TITLE: SPECIAL PERMIT NO. 1988, TAMARIN RIDGE COMMUNITY UNIT PLAN, requested by Brian D. Carstens and Associates on behalf of Susan and Donald Brouse, Thomas Folsom and National Bank of Commerce Trust and Savings Association, for approximately 441 dwelling units, with waiver requests, on property generally located southwest of the intersection of South 27th Street and Porter Ridge Road.

LINCOLN CITY/LANCASTER COUNTY PLANNING STAFF REPORT

P.A.S.: Change of Zone #3381 **DATE:** November 25, 2002
Special Permit #1988 for C.U.P.
Preliminary Plat #02019 - Tamarin Ridge
Special Permit #1989 for Planned Service Commercial in H-4
Use Permit #147

**CHANGE OF ZONE
SPECIAL PERMIT / C.U.P.**

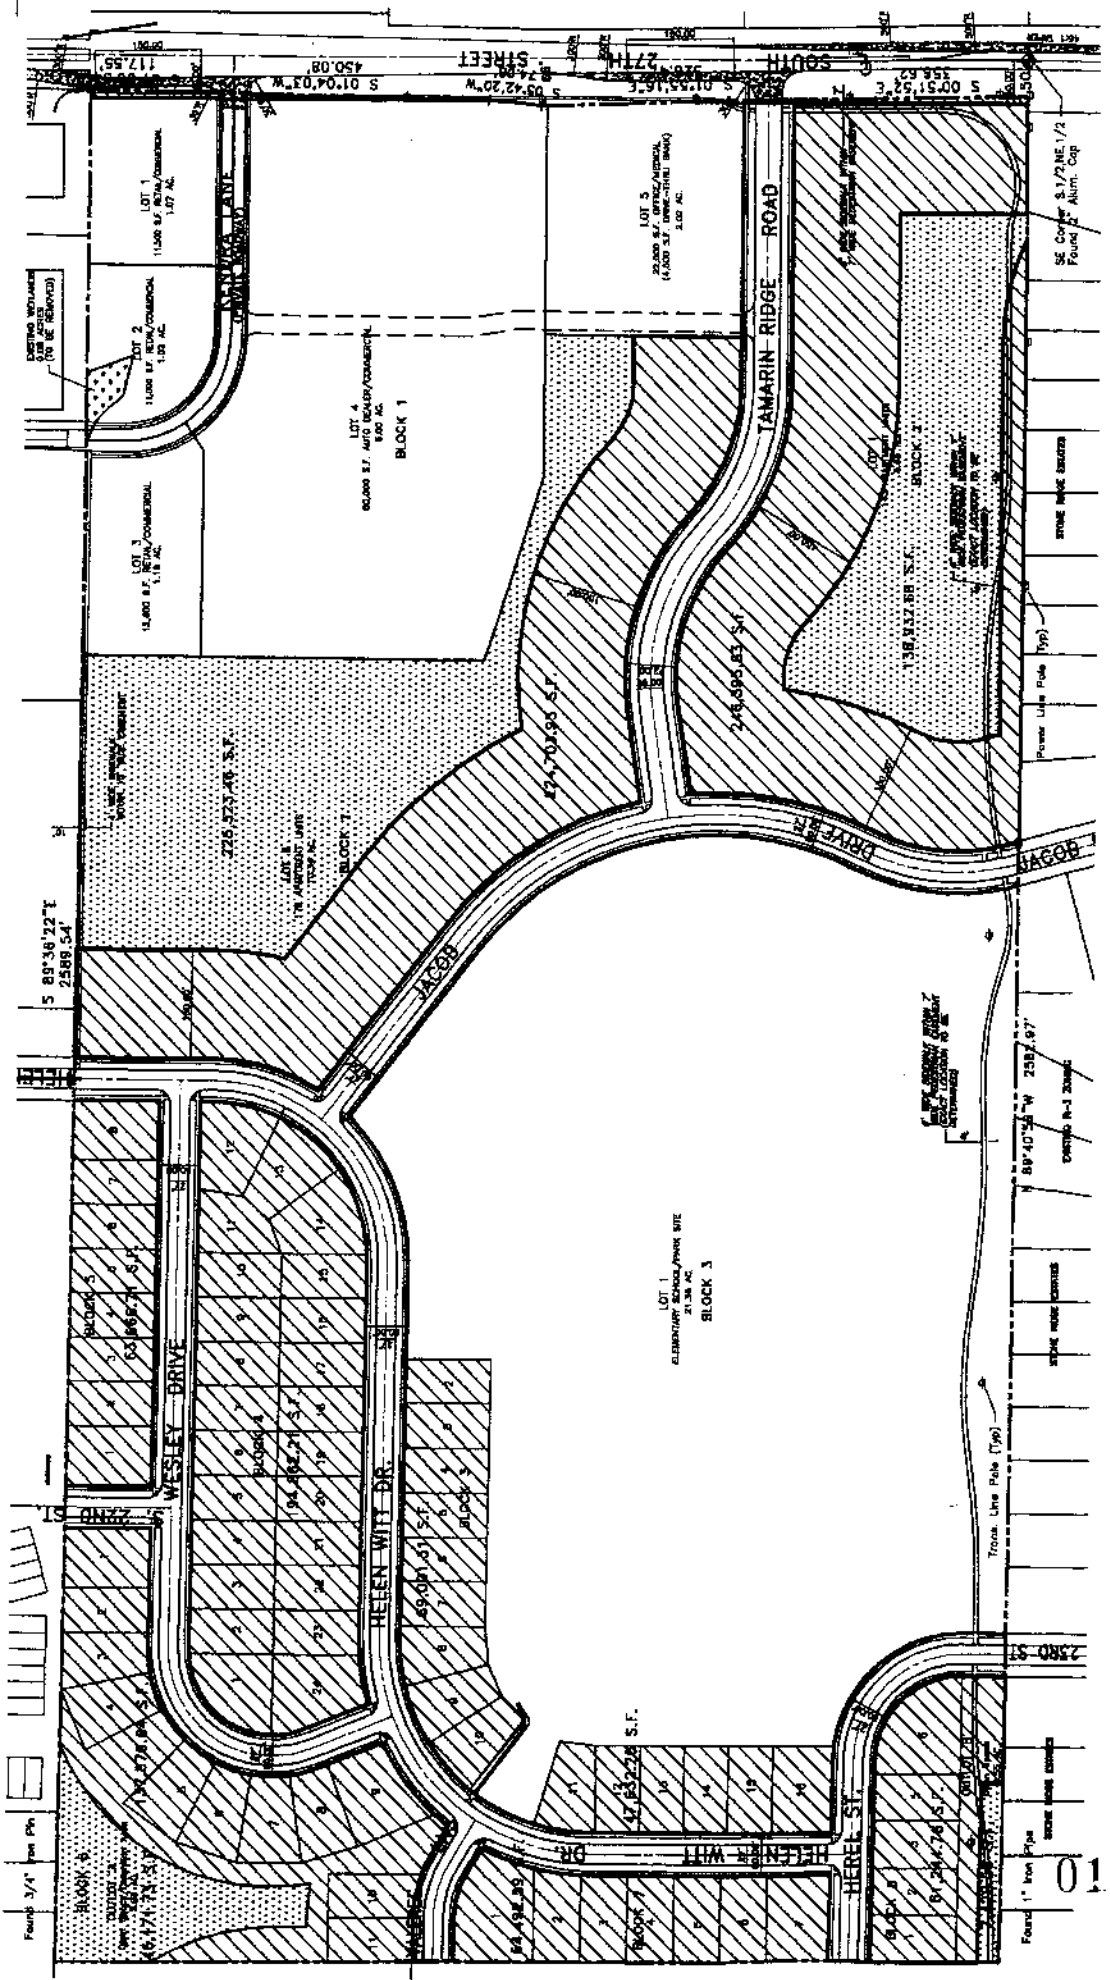
- 1.1 Revise the site plan to show:
 - 1.1.1 The setback from the property line increased one foot for every one foot the building height exceeds 35'.
 - 1.1.2 Revise CUP General Note #5 to include language that the recreation plan shall be approved at time of building permits.
 - 1.1.3 Delete CUP General Note #6 relating to the timing of the installation of a landscape screen on Lot 6, Block 1.
 - 1.1.4 Revise the density calculations for Lot 6, Block 1 (math error).

1.1.5 Revise the Land Use Table to show six lots for Block 3, Lots 11-16, and to show Block 8, Lots 1-5 (not 1-6), and correct the cumulative totals.

1. The 6" water main in Herel Street has been revised to be shown as a 12" water main, as requested.
2. The water main in front of the commercial lots has been shown as a 8" water main, as requested.
3. The grading has been revised along the north boundary to allow for less fill over the proposed sanitary sewer, thus meeting design standards, as requested.
4. Lyle Loth has revised the grading and drainage plans as requested.
5. The traffic is attached with this submittal. The traffic study was prepared by the Schemmer & Associates.
6. Kendra Lane, the private roadway, has been widened to 33' wide, as requested.
7. We have shown a proposed centerline profile for the future 27th Street pavement improvements, as requested.
8. The traffic study identifies the acceptable distances. Our site plans show a larger distance for stacking between South 27th Street and the north/ south driveway.
